ADDENDUM NO. 1

Date of Addendum: 4/24/14

PROJECT NAME: Rehabilitation of Pumps, Motors, Valves, Piping and Buildings at Various Facilities

PROJECT NO: WBS No. S-001000-0036-4

SB-E-21R

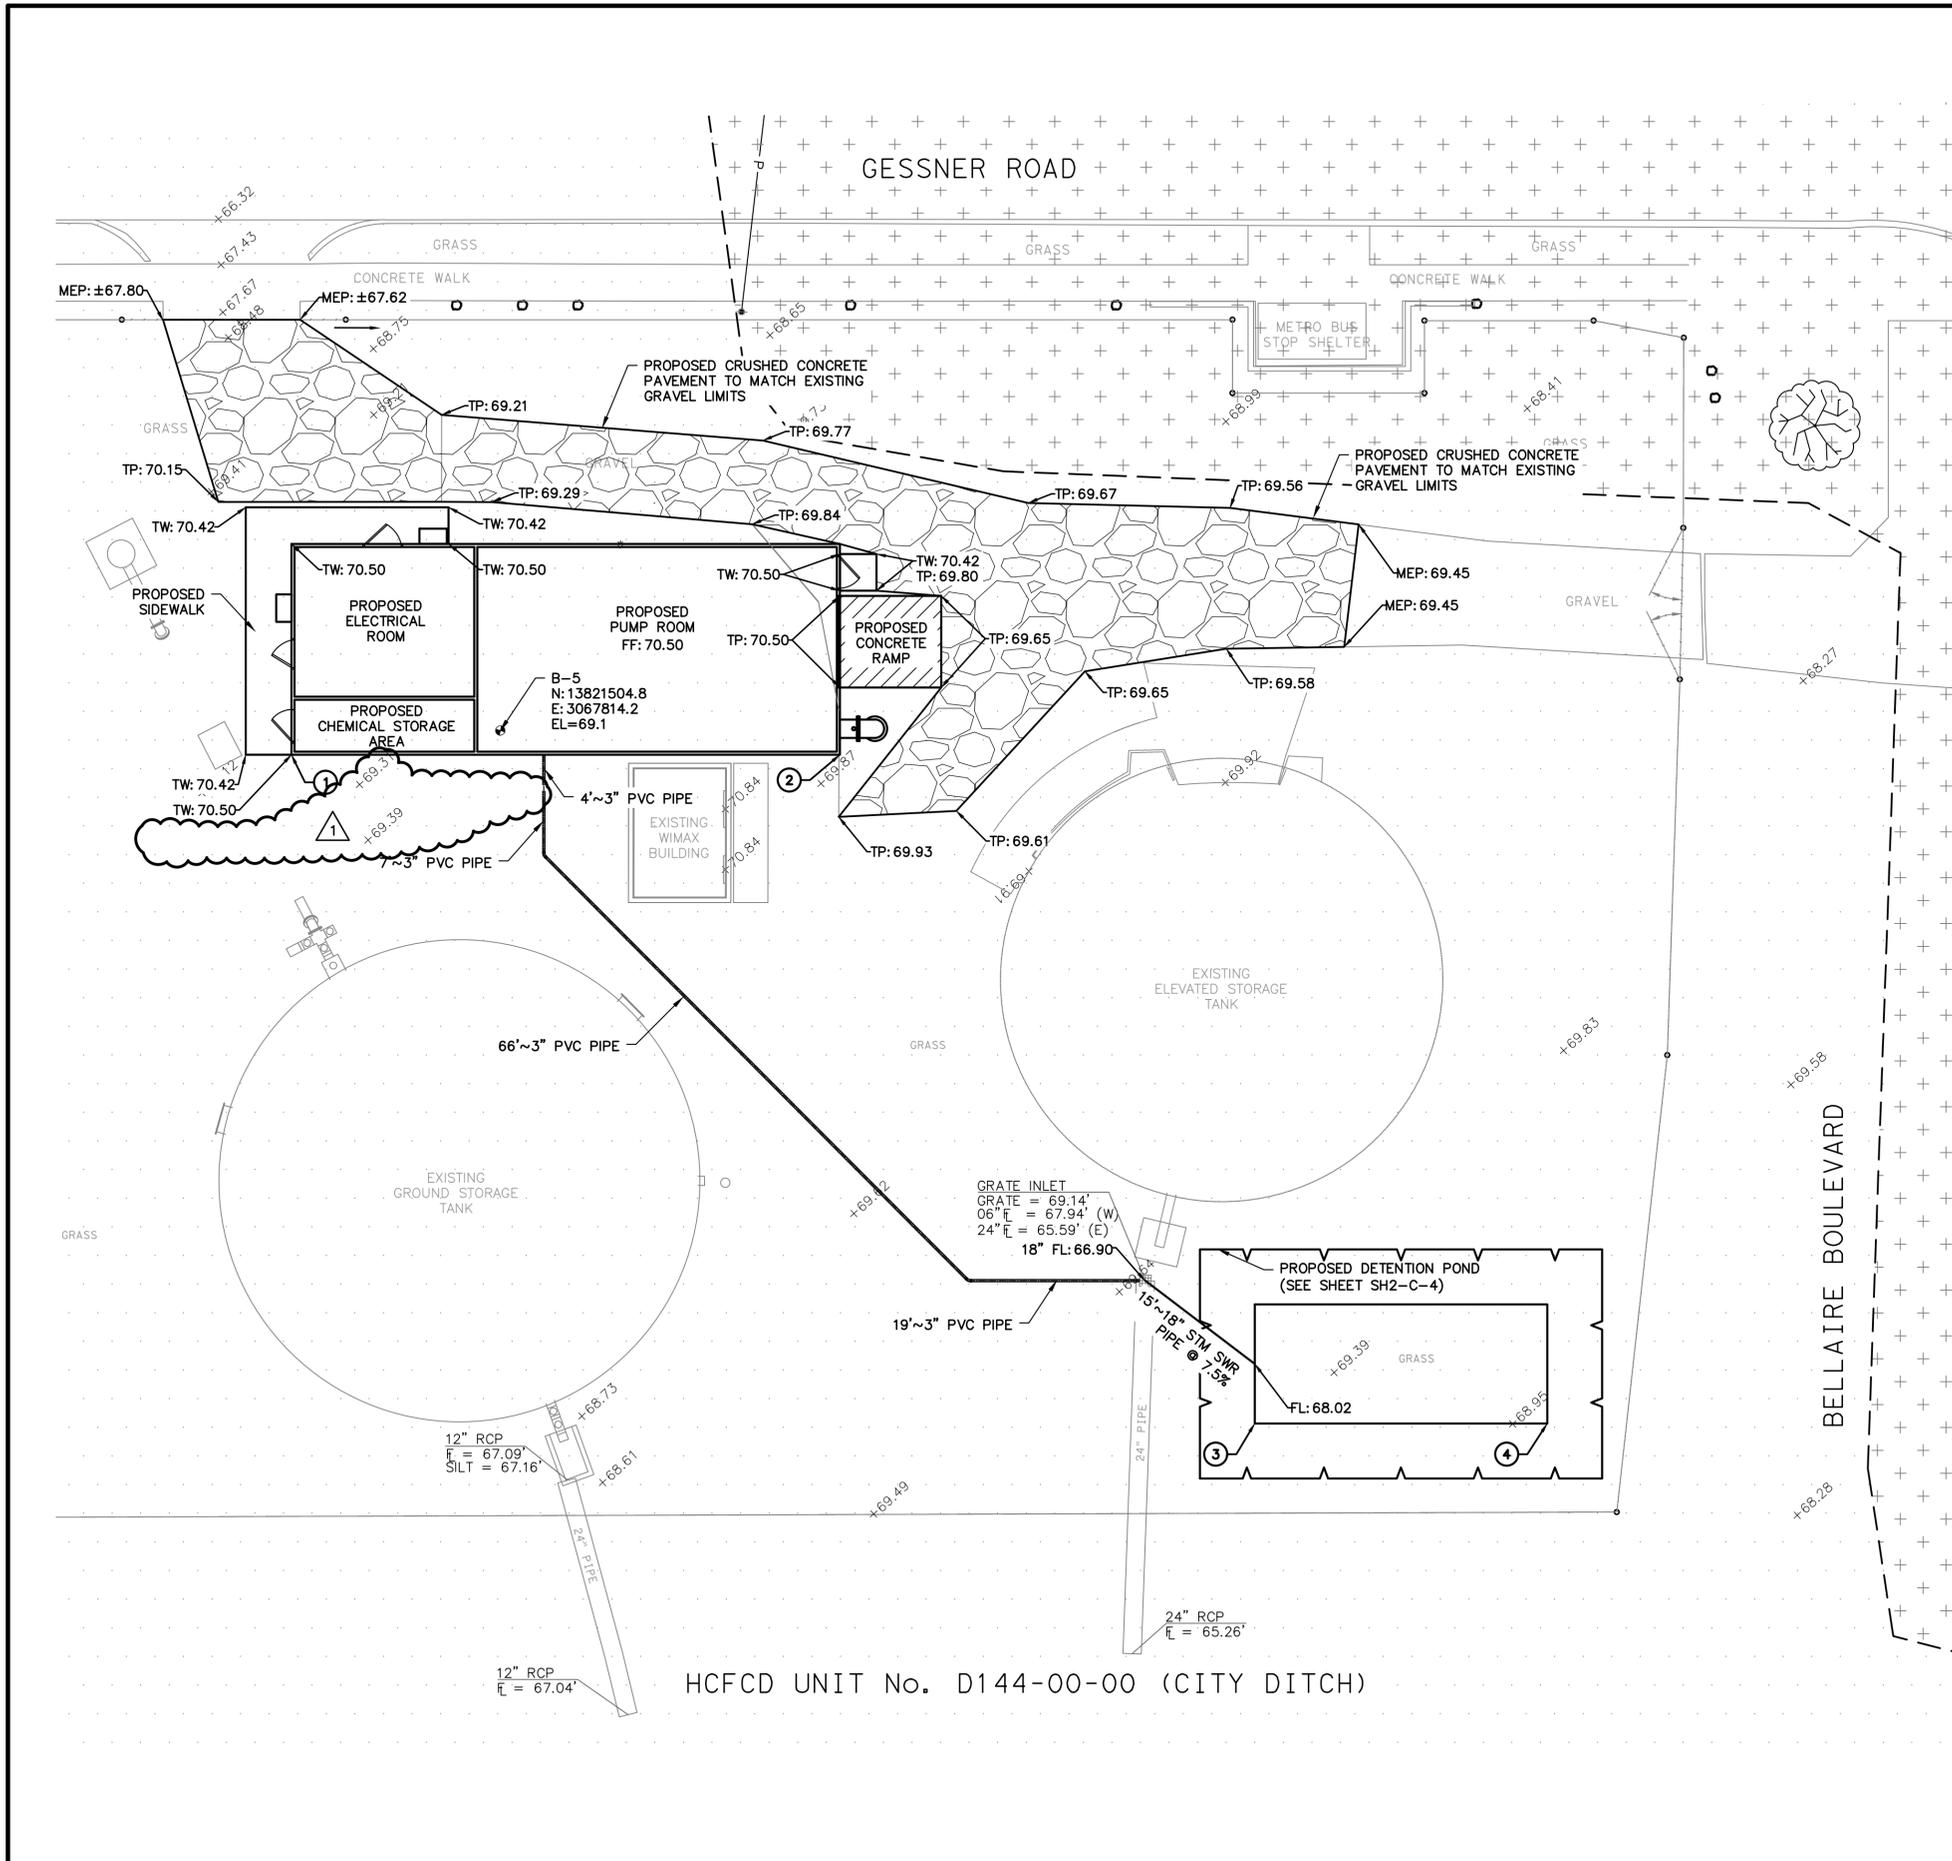
36. Delete Sheet SB-E-21, Proposed Control System Architecture Diagram, and replace with revised Sheet SB-E-21R.
  37. Delete Sheet SH2-C-2, Proposed Overall Site Plan, and replace with revised Sheet SH2-C-2R.

- NOTES:
- ① SIEMENS PANEL 6AV7885-5AK21-7EA3-IPC577D
  - ② VIA WIREWAY.
  - ③ EQUIPMENT LOCATED IN EXISTING PLC PANEL IN EXISTING PUMP BUILDING.

SECTION A  
3/8"=1'-0" SH2-M-1

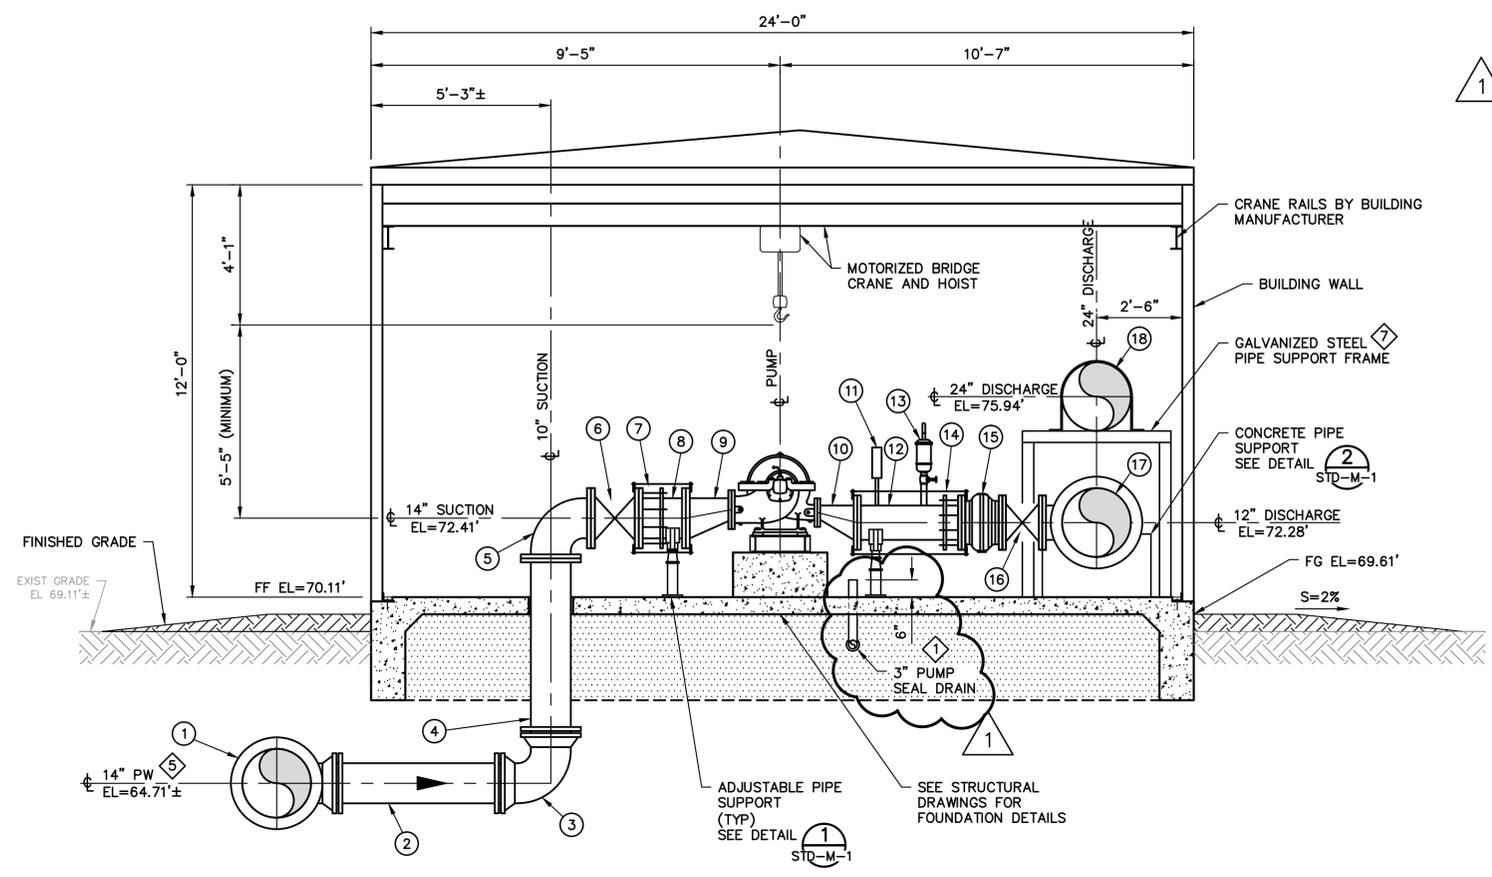
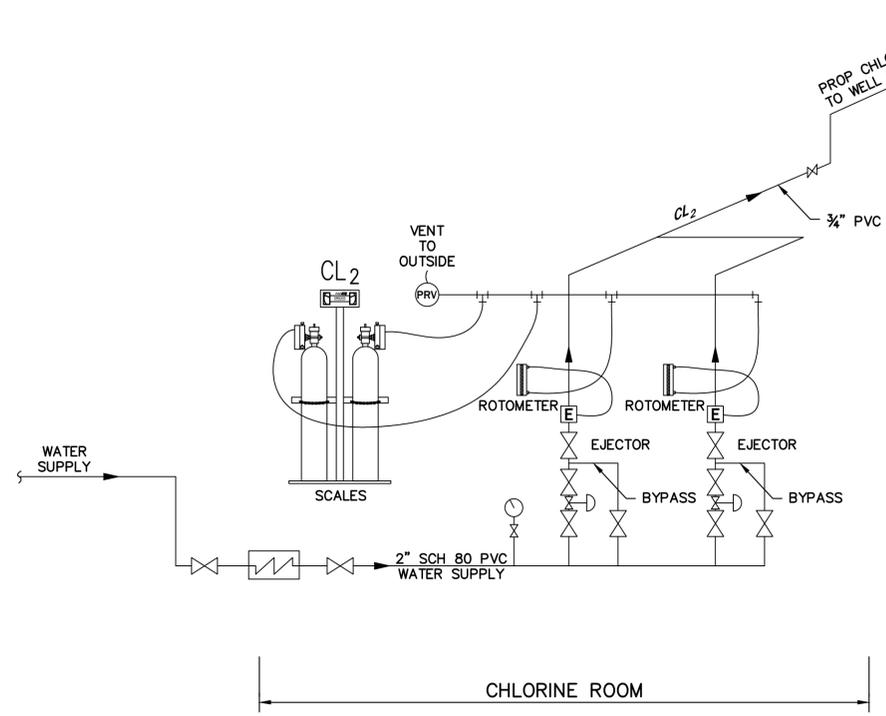
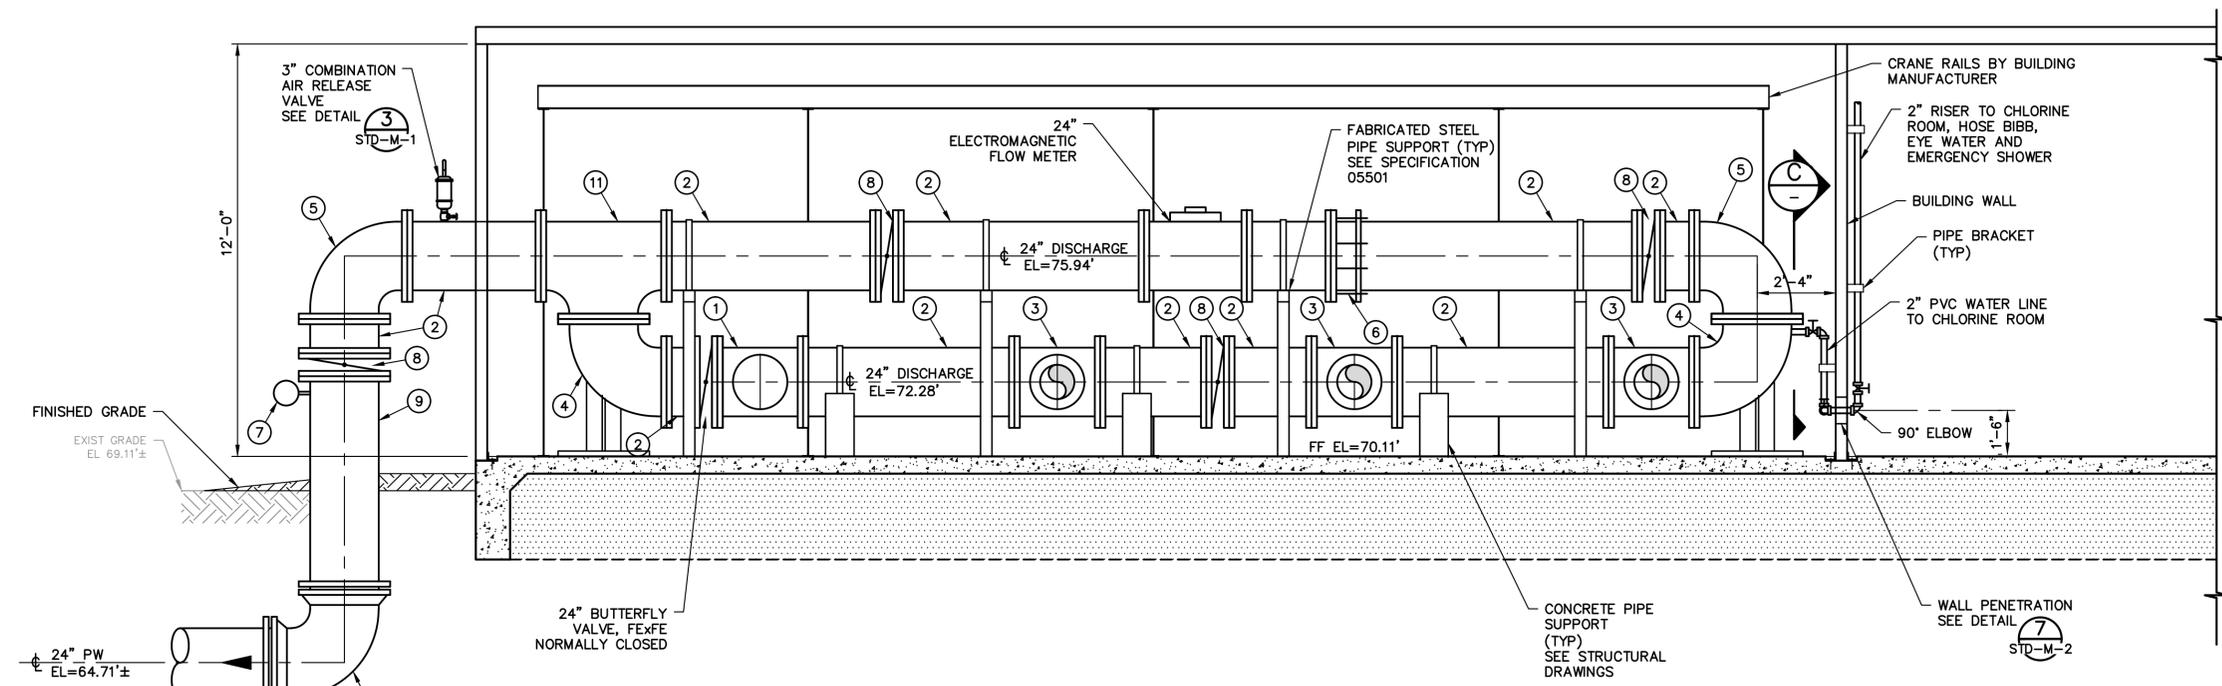
40. Delete Sheet SH2-M-1, Booster Pumps and Piping proposed plan, and replace with revised Sheet SH2-M-1R.
